# CITY OF PORTLAND

Permit Number 041569

This is to certify that Garand Susan E & /Owner  
 has permission to build 26x36 interior non-bearing wall with 6x36 and 6x34 two story deck to wrap the garage  
 AT 821 Ocean Ave Portland, OR 97202 422 B016001

# All Purpose Building Permit Application

1/8" scale 2nd floor plan

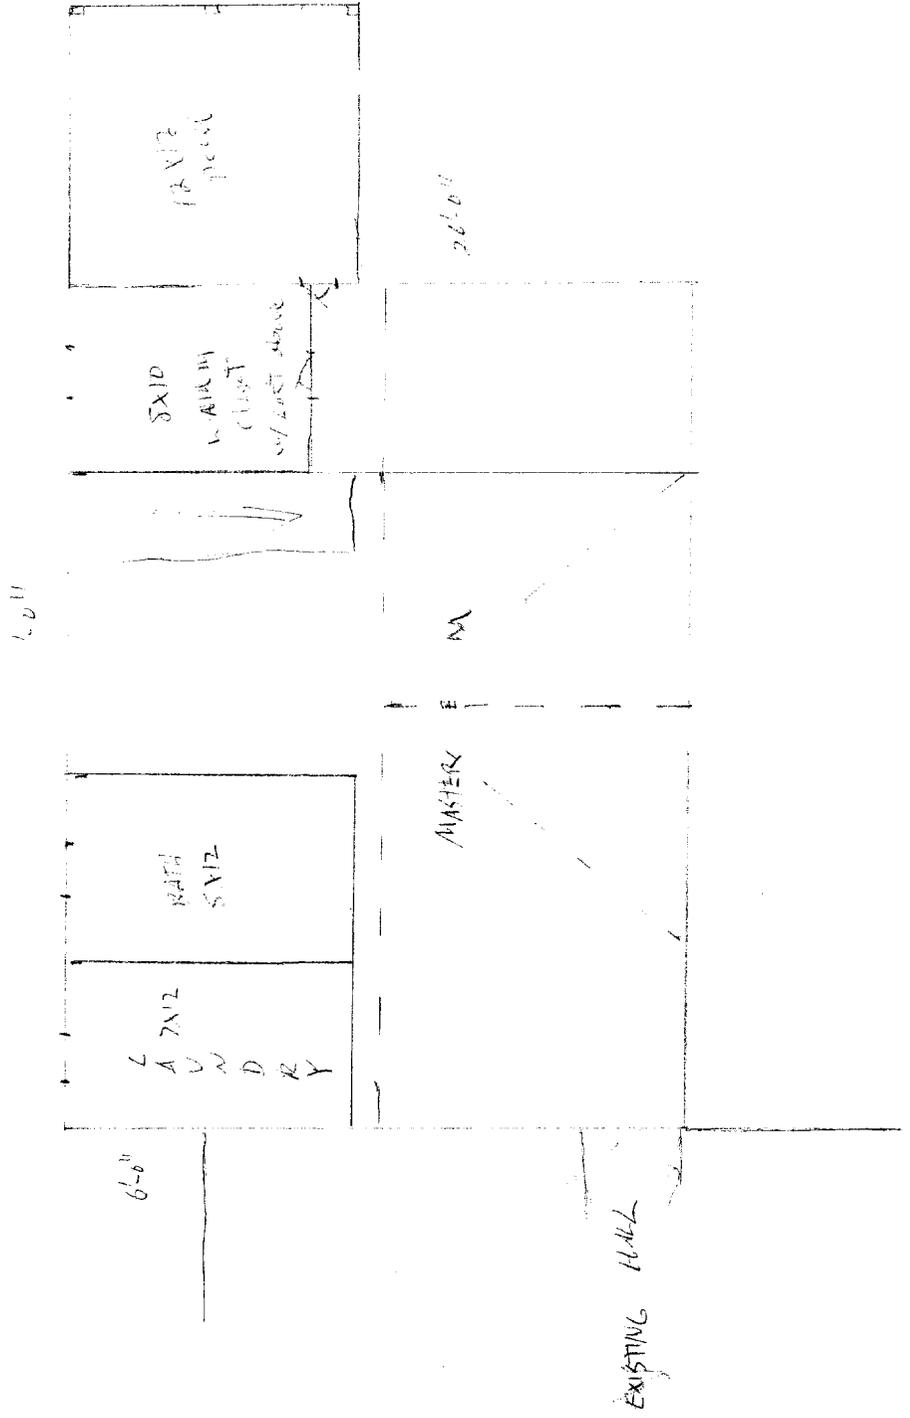
10/20/04-tmm: called owner - drawings very inadequate. Need full set of plans.

1/8" scale Basement Plan

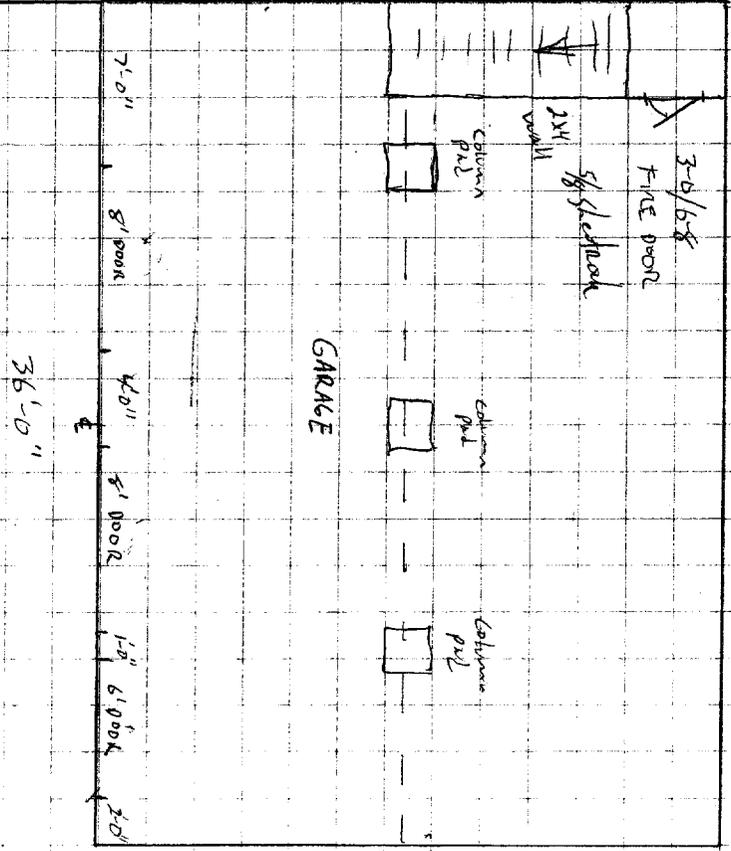
- ① Steel Beam engineered + must be posted all the way down to the foundation
- ② LVL sizes
- ③ 12" Tubes must be 48" below grade - ⑭ 2nd floor deck detail

- Steel Beam engineered + must be posted all the way down to the
- LVL sizes - stamped plans foundation
- 12" Tubes must be 48" below grade - 3rd floor deck detail same as 1st floor
